AGENDA
RIO DELL PLANNING COMMISSION
REGULAR MEETING - 6:30 P.M.
TUESDAY, MAY 23, 2017
CITY COUNCIL CHAMBERS
675 WILDWOOD AVENUE, RIO DELL

- 1) 2017/0523.01 - Resolution No. PC-109-2017 Approving the Design Review Conditional Use Permit for PMD, Incorporated for the development of three (3) buildings. Building 1: (4) unit retail commercial. Building 2: Warehouse, distribution, and packaging. Building 3: Cannabis Testing Lab (DigiPath), concentrate manufacturing, research and development of cannabis medicinal products, and tissue culturing and plant nursery subject to Conditions of Approval APN 205-111-021 - Case No. DR-CUP 17-02 (**DISCUSSION/POSSIBLE ACTION**) 12

Subject: PMD Inc. Design Review Conditional Use Permit
File No. 205-111-021; Case No. DR-CUP 17-02

SHEET NAME
**BUILDING 2
ELEVATIONS**

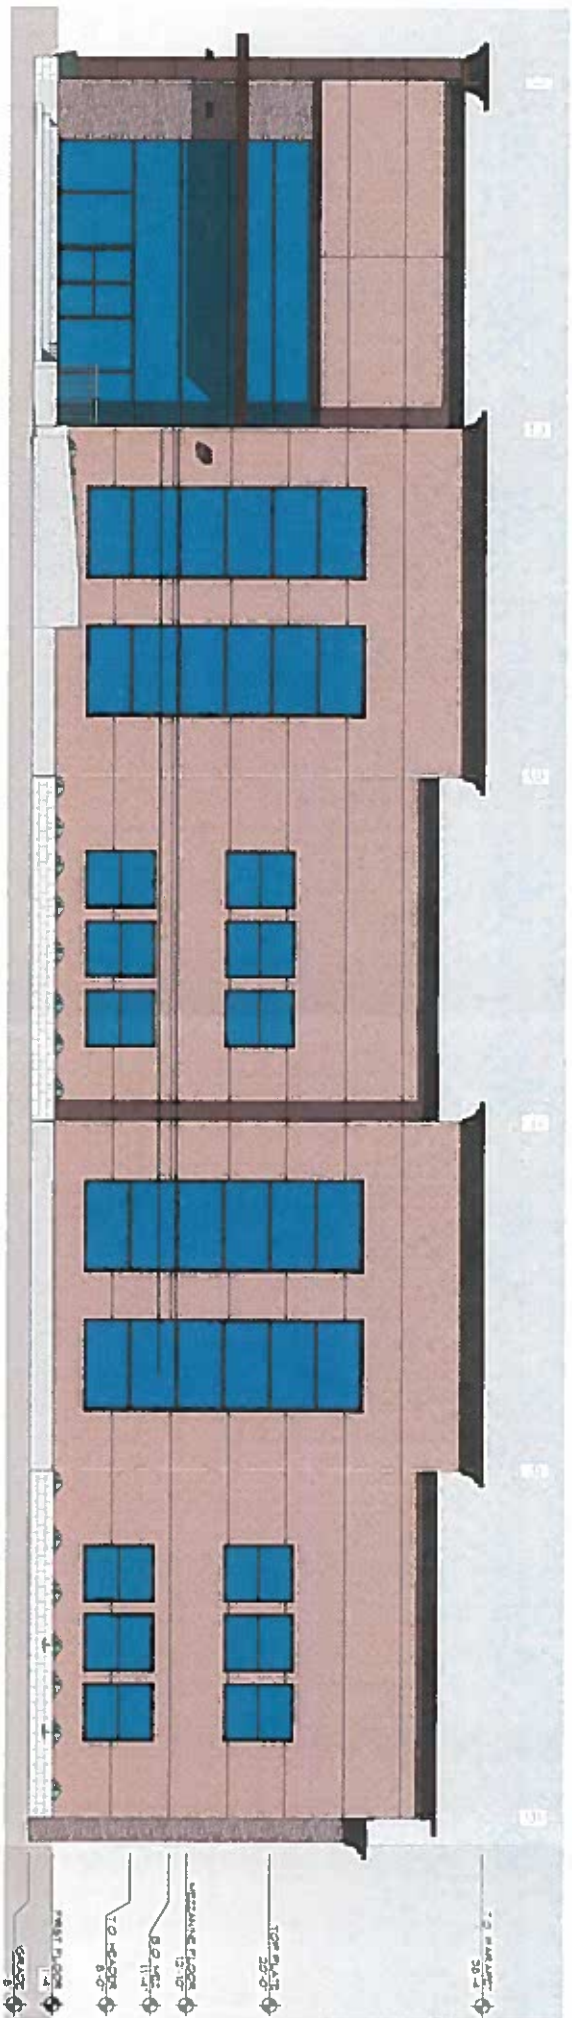
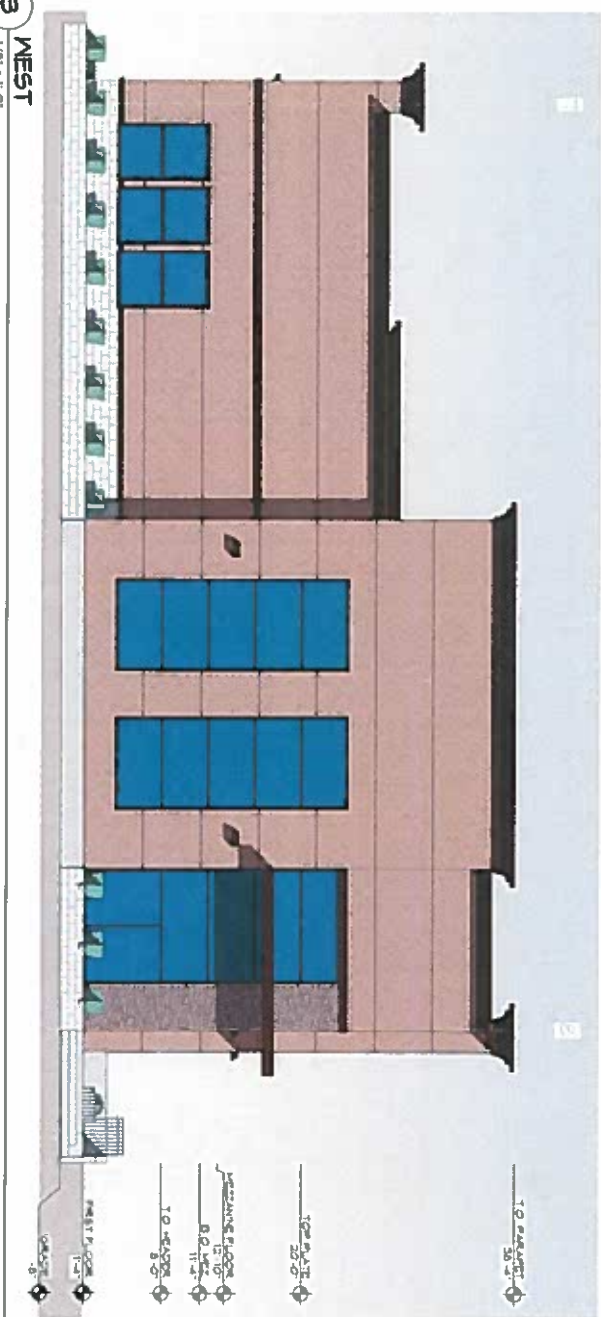
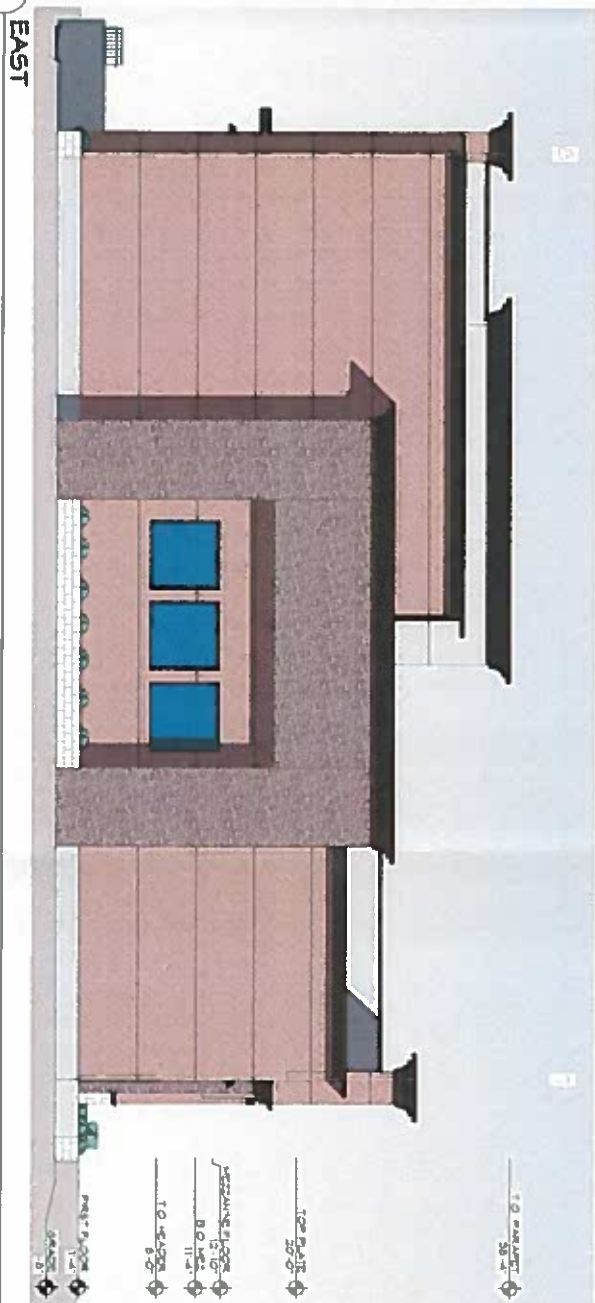
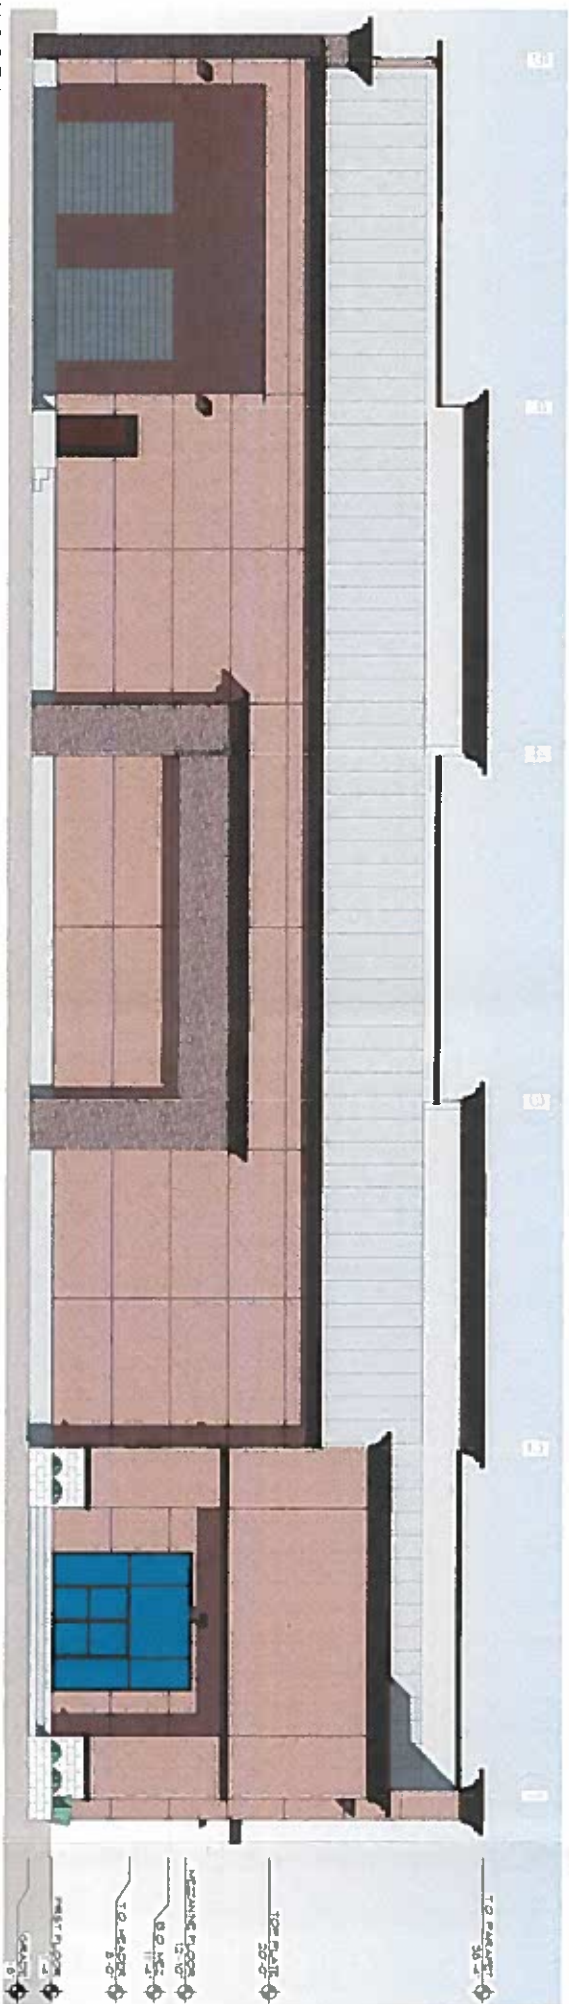
The proposed signage on the middle building will be two 75 square foot externally lit signs. The proposed signage on the southern building includes three 75 square foot externally lit signs. Please refer to Attachment 1.
